PRODUCT CHANGE NOTICE
PCN Form (D4-E000-73)

PCN#11-002-1

TC-series

Change of appearance of plastic substrate

AT224-1A

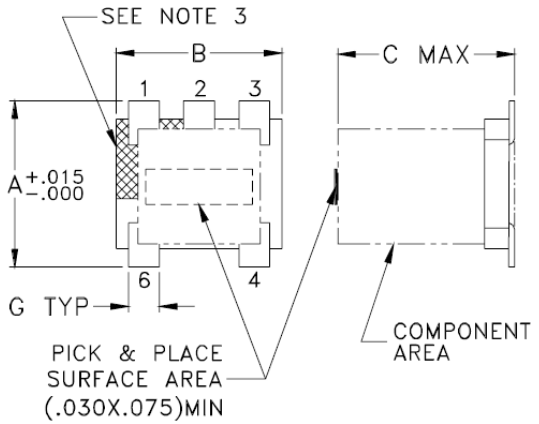
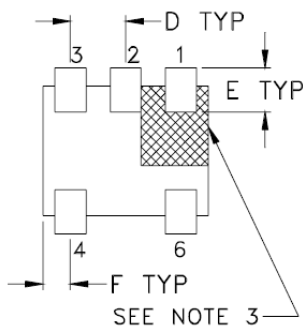
- No change in Fit, Form or Function
- Slight change in appearance of the substrate
